Re: Rish Park Advocates for Accessibility
Concerns for Further Discussion and Resolution

ATTACHMENT A

Rish Park Advocates for Accessibility

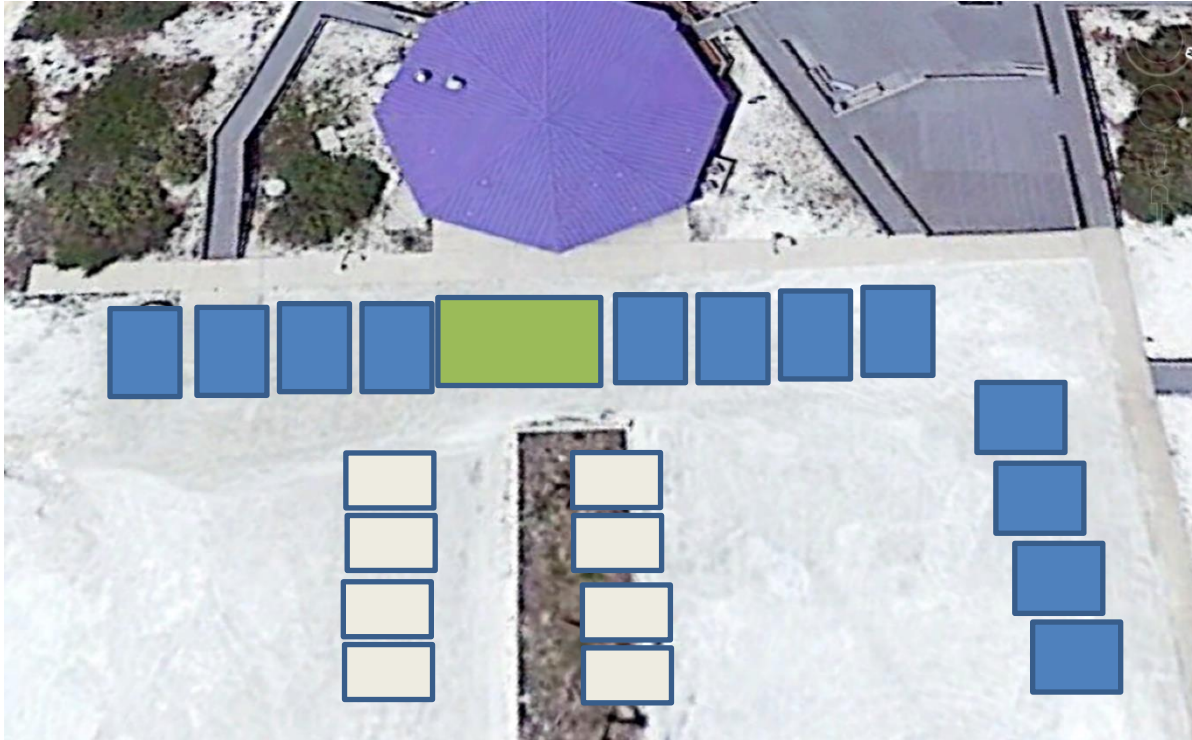
The following image from Google Earth shows an overhead of the facility main parking lot from April 2019.

As the members of our group are well aware, the main parking lot today continues to not include ADA-compliant parking spaces. While FBC provides minimum requirements for required parking spaces at government community facilities (e.g., sport complexes, hospitals and rehabilitation facilities, etc.), our group recommends the above as a minimum to be designated as ADA-compliant parking spaces. While minimum requirements for handicap parking spaces (total and van-accessible handicapped) are typically based on a ratio of total required parking spaces, given how this particular facility is used and based on the requirements of Section 553.5041(4)(c), Florida Statutes (quoted below), all ADA-compliant parking spaces should be van-accessible and a sufficient number of spaces should be provided beyond the bare minimum. At least two to three spaces should be provided per family cabin, and another two to three spaces for each of the community cabins (16 to 24 spaces). An accessible passenger loading zone should also be provided near the main entrance and near the family cabins.

The above image shows a rough draft concept of layout for the locations (not including the parking lot at the north end of the Park) with dark blue van-accessible parking, green for an accessible loading zone, and light gray non-ADA compliant parking. Such design details as optimum traffic patterns, parking surface permeability (to meet coastal conservation needs), and distance minimizing for access can be discussed in a focus group.
